ADDENDUM NO. 1
to the Contract Documents for

ADA PARKING LOT RECONSTRUCTION
Waltham, Massachusetts

Addendum Date: May 12, 2015

SKETCH NO. **SKL-01**

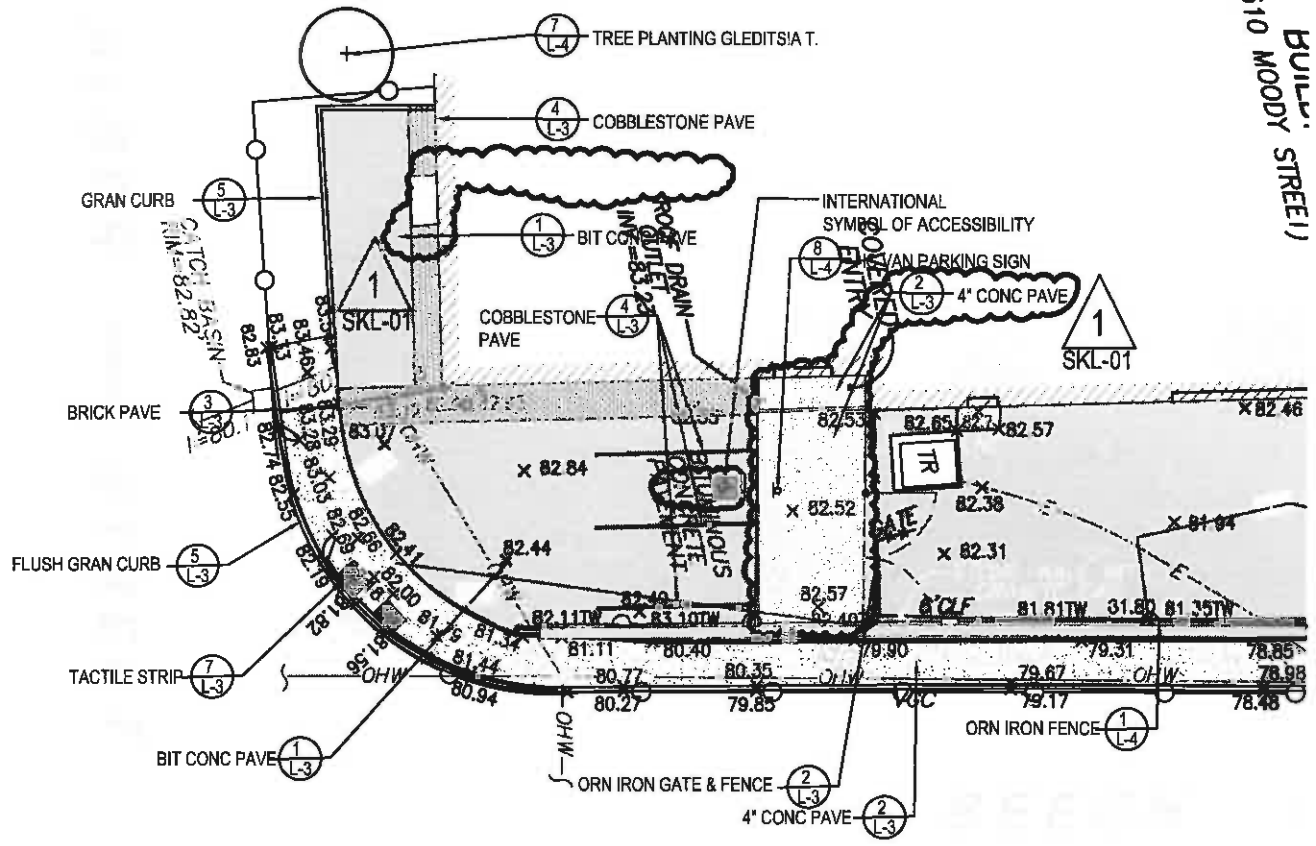
ITEM 01 Include attached SKL Drawings 01 – 03.
